THE ROVER COMPANY LIMITED

**LAND-ROVER SERVICE NEWS LETTER
No. 22**

May, 1962

Fig. 1—Altitude corrector in position.

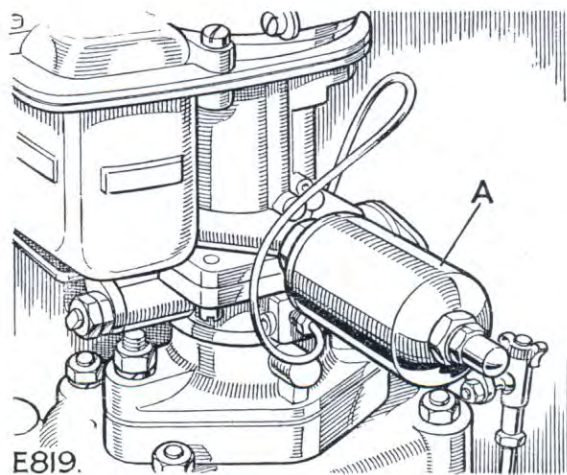
Item 112 SUBJECT: AUTOMATIC ALTITUDE CORRECTOR

REMARKS: Stocks of an automatic altitude corrector for use on Land-Rover Series II and Series IIA models are now available from our Parts Department. The altitude corrector, which is fitted in place of the main jet and main jet carrier, see Fig. 1 below, gives improved performance and fuel economy, when the Land-Rover is being used at high altitudes. This is particularly so when operating at greatly varying altitudes.

Fig. 2—Location of fan cowl steady strip.

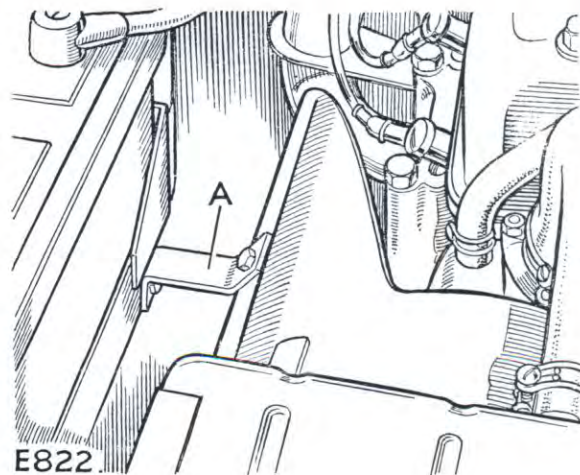
- Item 115** SUBJECT: **FAN COWL**
 MODELS: Land-Rover Series IIA 2 $\frac{1}{4}$ litre Petrol.
 MODIFICATION: Introduction of a steady strip for the fan cowl to eliminate vibration of the cowl against the engine front cover on Land-Rover petrol models only.

REMARKS: The steady strip can be fitted to any earlier Land-Rover Series IIA petrol model as shown in Fig. 2.
